# Access Compliance Report Public Rights-of-Way (Curb Ramps)

Main Street: LIVINGSTON\_AVE Cross Street: KIRK\_AVE Location: NE

ADA ID: RPAT211004093833 Ramp Type: Type 1 - Perpendicular Diagonal Initial Pass/Fail: Pass Overall Compliance: No Severity Score: 2

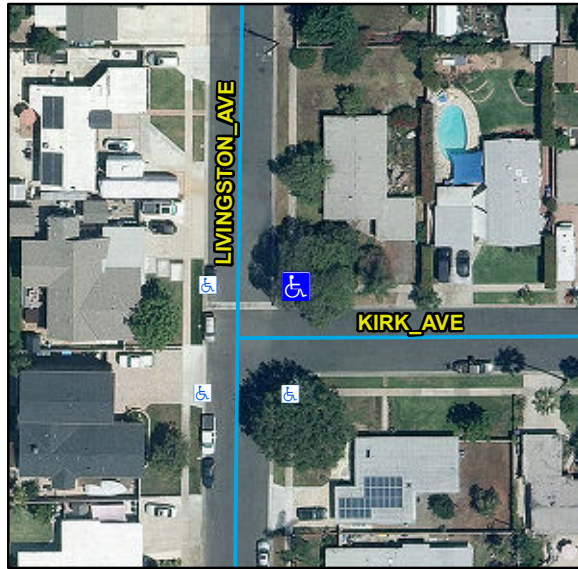
R304.2.2, R304.2.1, STD 1115

| Compliance | Description                           | Data | Compliance | Description                   | Data   |
|------------|---------------------------------------|------|------------|-------------------------------|--------|
| Yes        | Gutter Ponding                        | No   | No         | Curb Slope                    | 5.9    |

Remove & Replace Curb Ramp With Two New Directional Ramps or Equivalent.
